CITY PLANNING COMMISSION

APPLICATION: Plan Review of three duplex structures on 0.6+ acre in the Multi-Family-Review (R-3-R) Zone

LOCATION: West terminus of Coral Gable Court

P87-271

EXHIBIT A

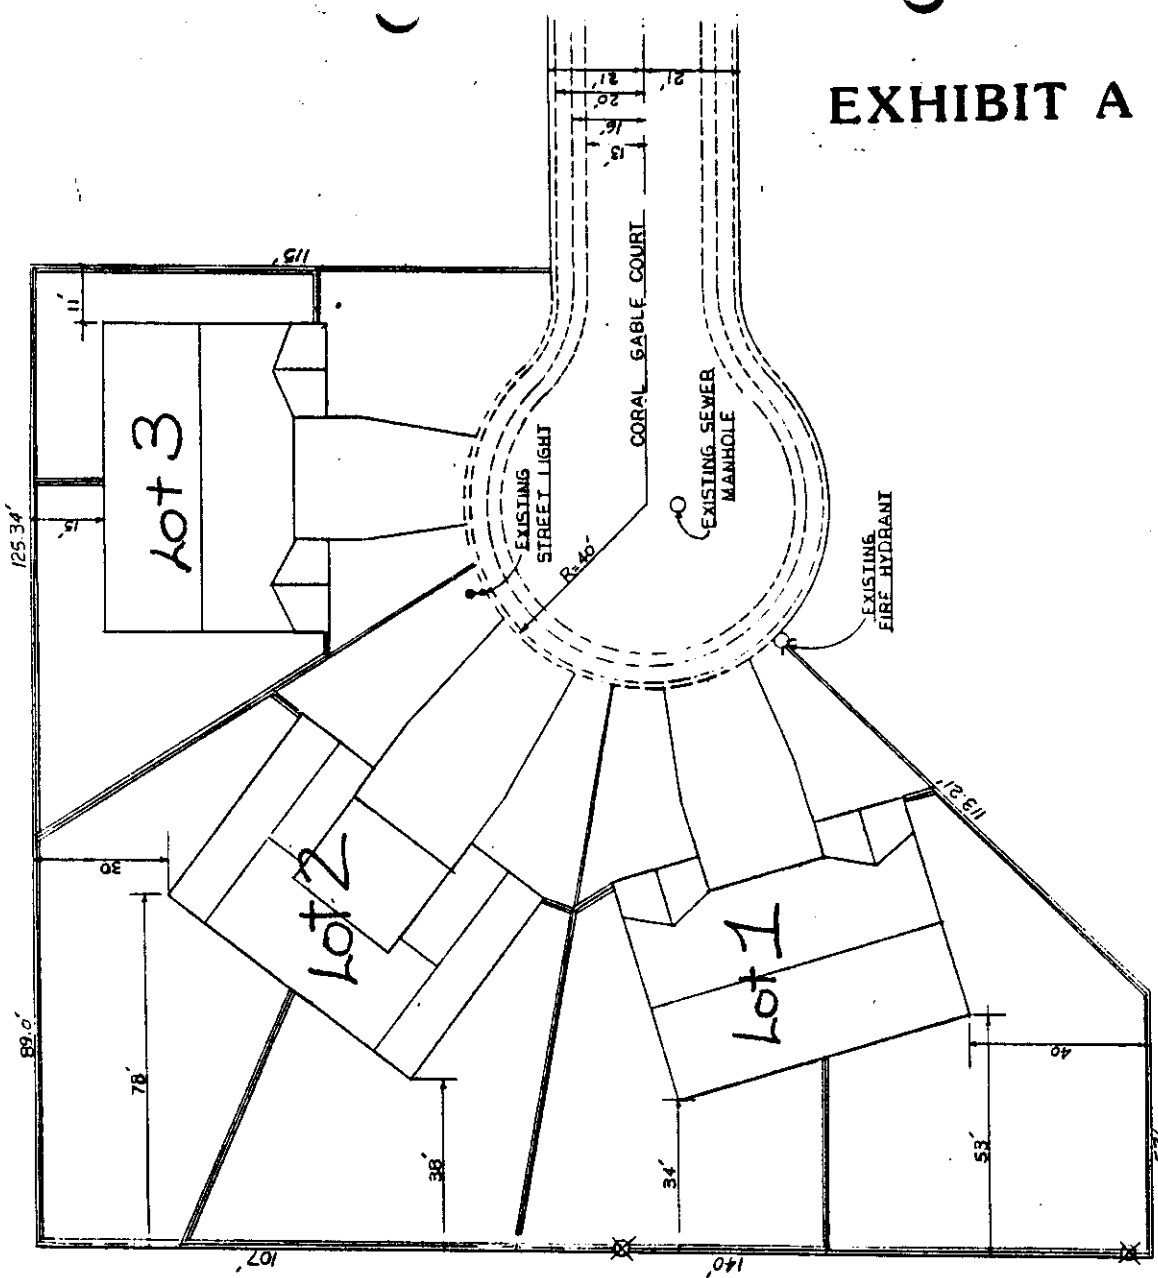
The proposed site plan and landscape plans indicate front yard landscaping for each duplex and 6' high solid wood fences designating the rear yard area of each unit. Planning staff recommends that the landscape plans be revised to indicate a minimum of two 15-gallon trees in the front yard of each lot (one tree per unit as shown on landscape plan for Lot 3), grass in the rear and side yard areas, and that the applicant provide an automatic sprinkler system for each of the duplexes. In the rear yard areas staff also recommends that a concrete patio be provided adjacent to the sliding door of each unit.

1. A solid 6' high wood fence shall be provided as shown on the submitted site plan (Exhibit A).
2. Revised landscape and irrigation plans shall be submitted for Planning Director review and approval prior to issuance of building permits. The revised plans shall indicate the landscaping shown in Exhibits G, H and I and the following additional information:

- c. Installation of an automatic sprinkler system.
3. The applicant shall revise the site plan to indicate a concrete patio area adjacent to the sliding door of each unit prior to issuance of building permits.

EXHIBIT C

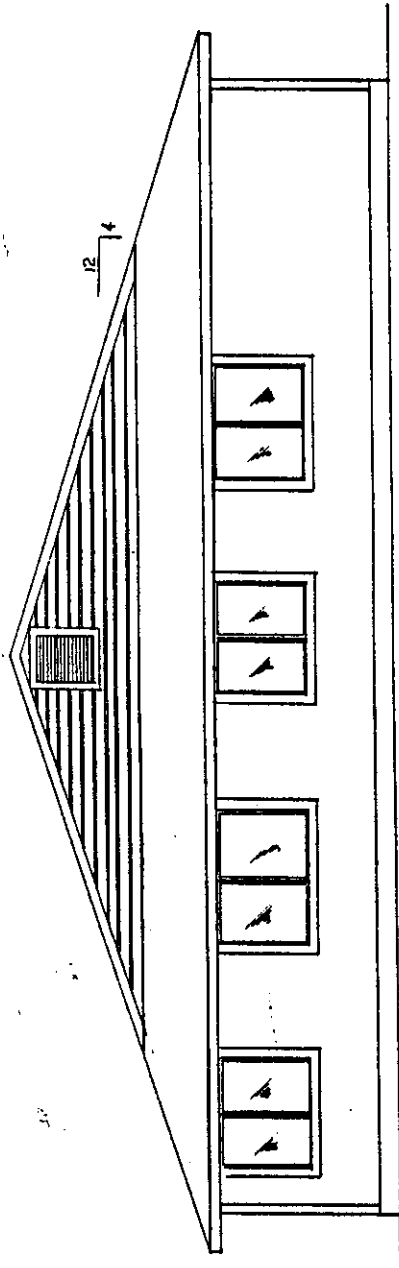
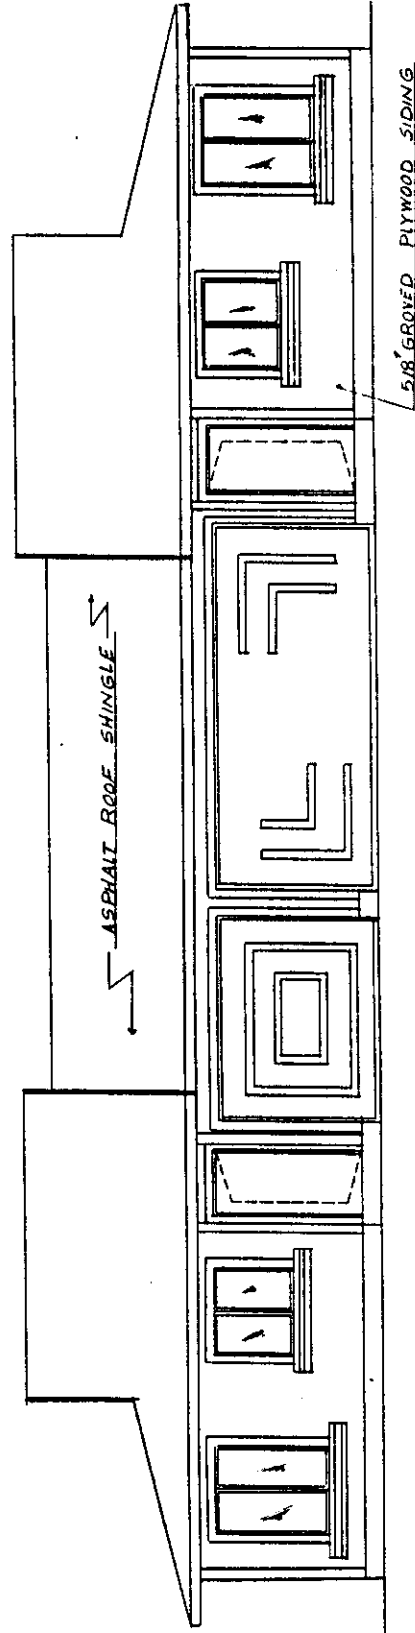
Planning staff recommends that the windows located on the front elevations of all three duplexes be paned windows in order to provide a more attractive appearance from the street. A brick veneer wainscoting should also be added to the front elevation of Type B and constructed on Lot 1 and/or Lot 3. Staff also recommends that the roof plan of Type B be revised to provide more movement from the street frontage. A previous roof plan previously submitted by the applicant is more attractive (Exhibit J). The air conditioning units for the duplexes are located on the roofs and these should be screened so that they do not visually intrude on neighboring properties. Staff recommends that the roofing material be a thick butt asphalt shingle with a 25 year rating. As building colors are not proposed at this time, staff recommends that each duplex structure have a different color scheme and that two compatible colors be used on each duplex (i.e. the trim of the duplex should be different from the rest of the structure).

4. Revised elevations shall be submitted for Planning Director review and approval prior to issuance of building permits. The revised plans shall indicate the design and materials shown in Exhibits C, D, E and F with the following revisions:

- a. The windows located on the front elevations of all three duplexes shall be paned windows;
 - b. A brick veneer wainscotting shall be added to the front elevation of Type B and constructed on the duplex on Lot 1 and/or Lot 3;

EXHIBIT E

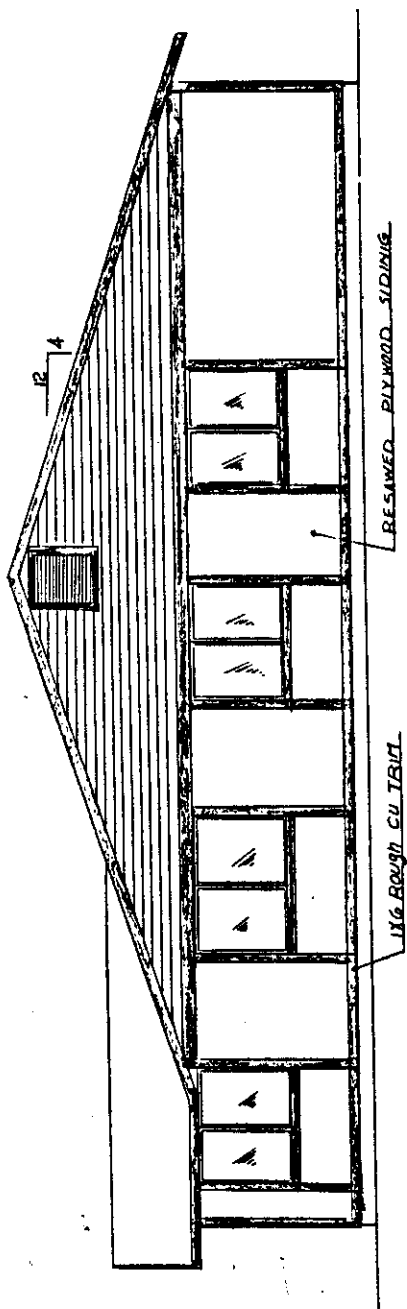
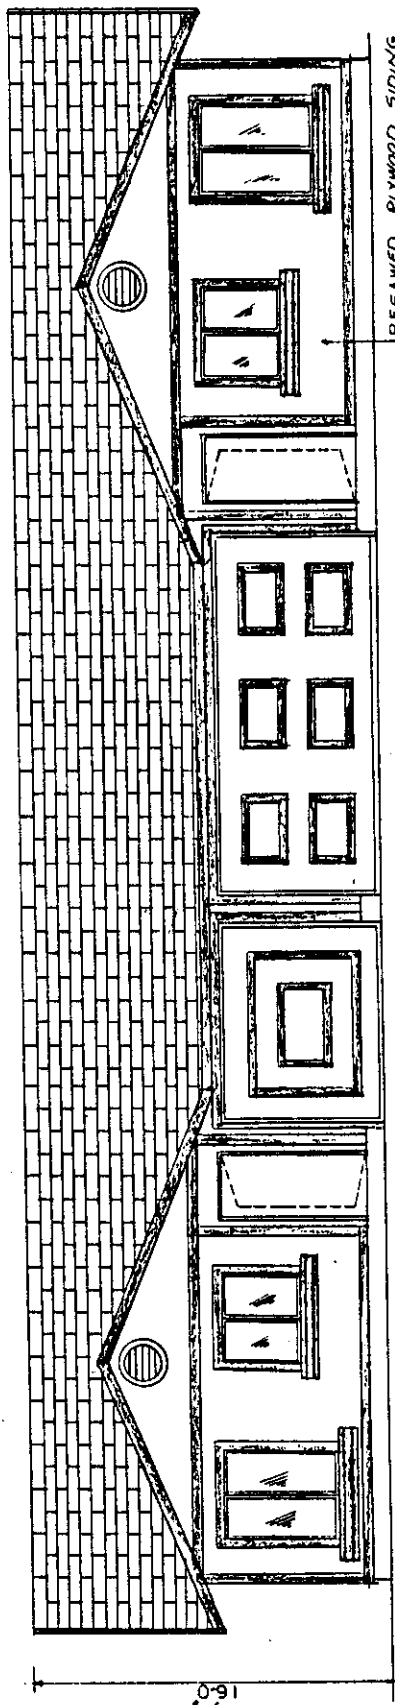
- c. The roof plan of Type B shall be revised to provide more movement from the street frontage, subject to Planning Director review and approval (suggested roof plans are indicated in Exhibit J);

EXHIBIT G

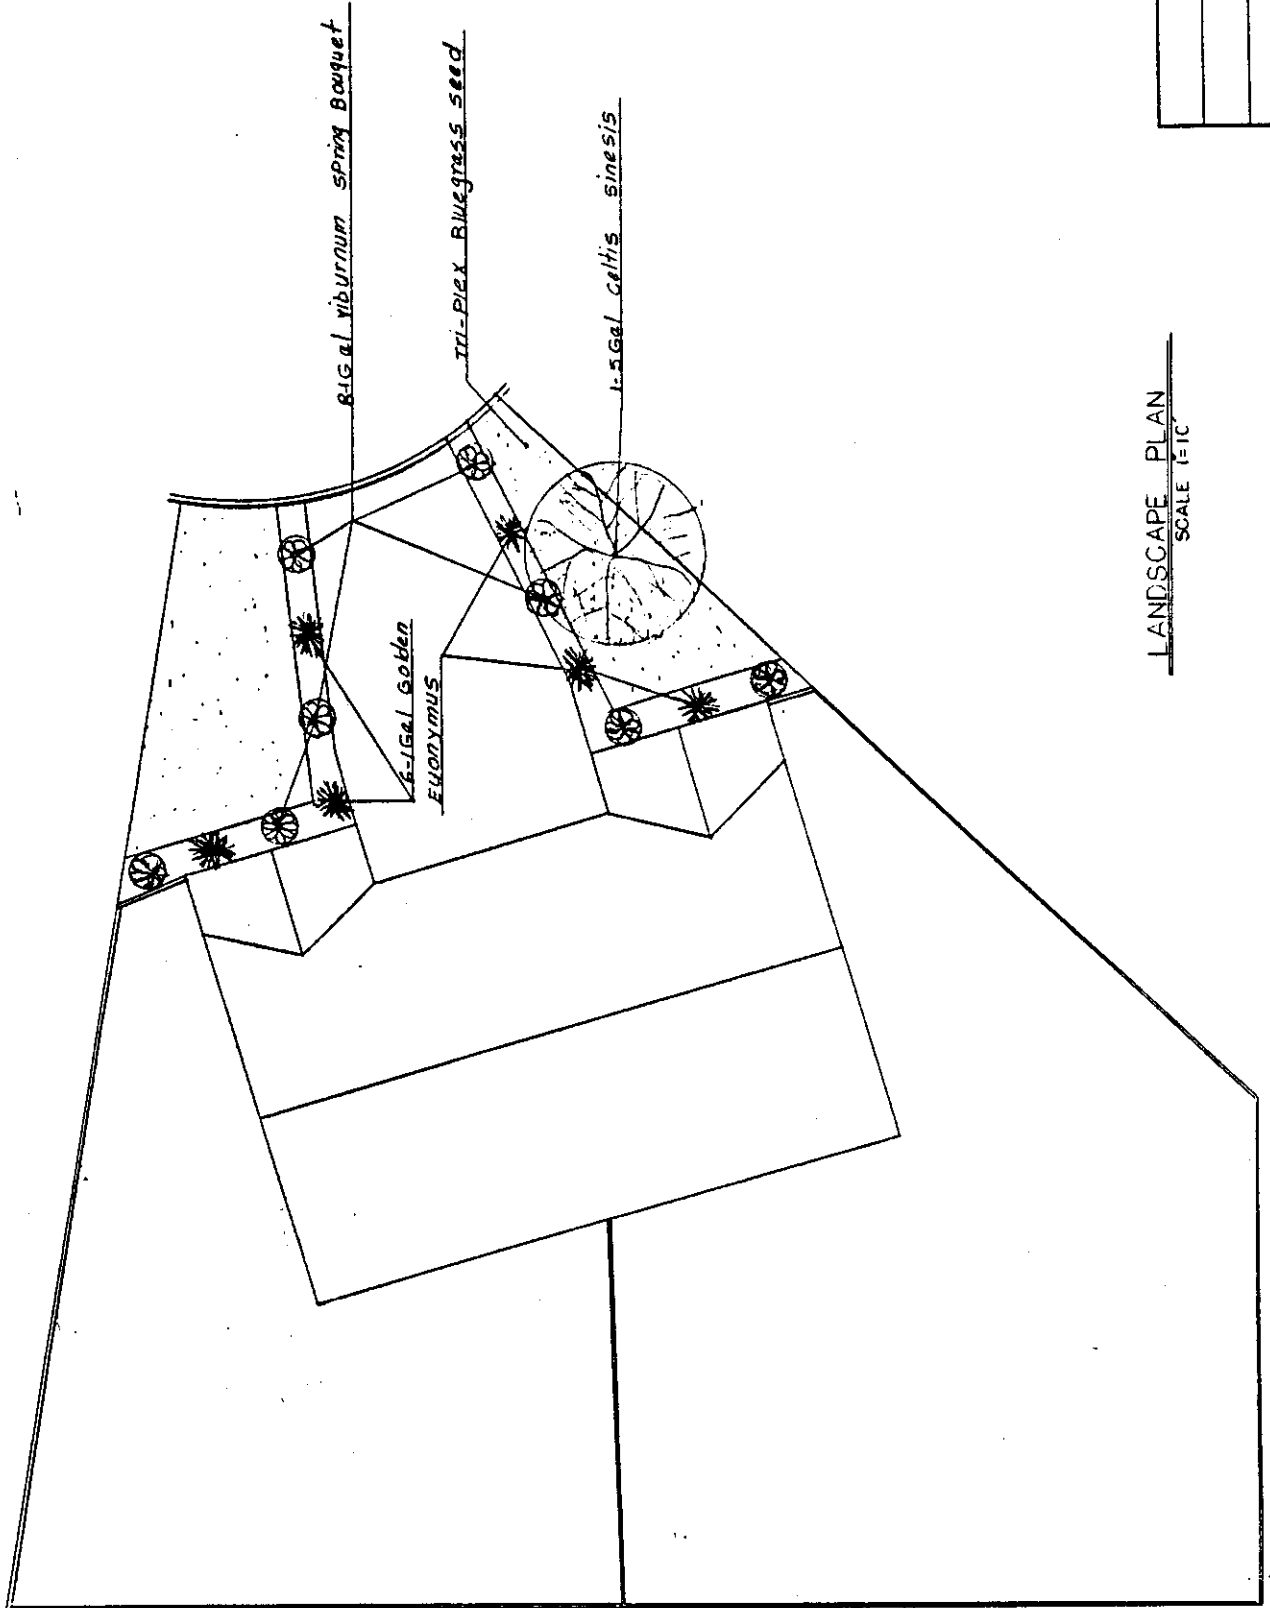
- a. Two 15-gallon trees per lot, located in the front yard setback area (one on each side of the duplex driveway) for a total of six trees;
 - b. Grass in the side yard and rear yard areas; and
